Ms. Ref. No.: EGUSPHERE-2024-3161

Title: Evaluating the feasibility of using downwind methods to quantify point source oil and gas emissions using continuous monitoring fence-line sensors

Reviewer comments

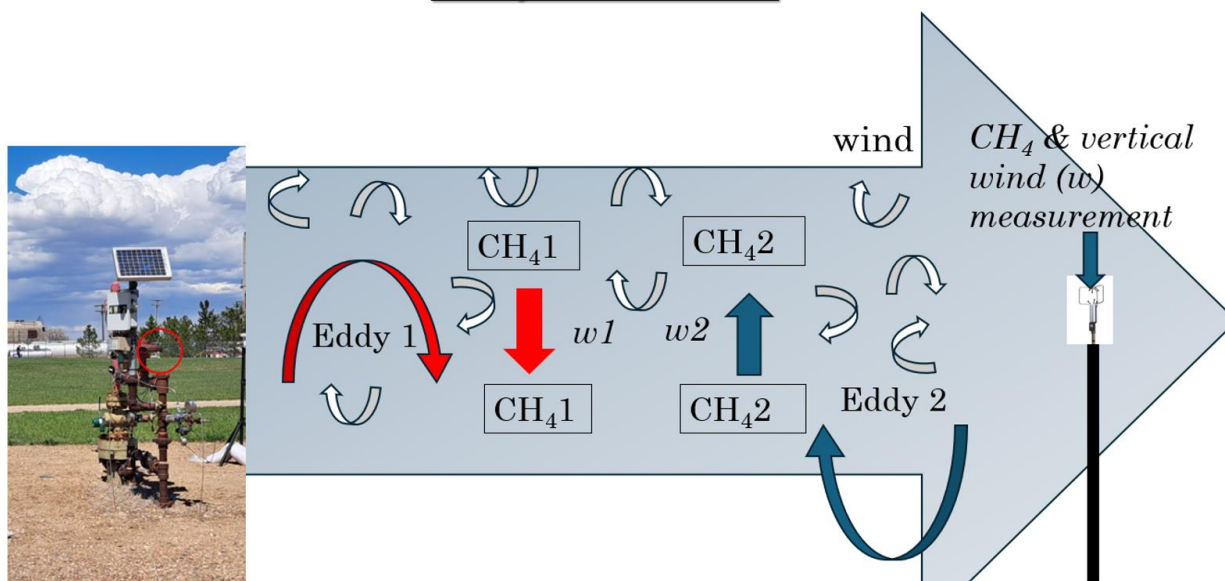
1. Figure 1A has an incorrect depiction of the eddy covariance method. It seems to imply downward eddies are negative fluxes and upward eddies are positive. In fact there are always both downward and upward eddies in contexts with either negative and positive fluxes.

Thank you for your comment. We have accordingly modified the depiction for eddy covariance and aerodynamic flux gradient
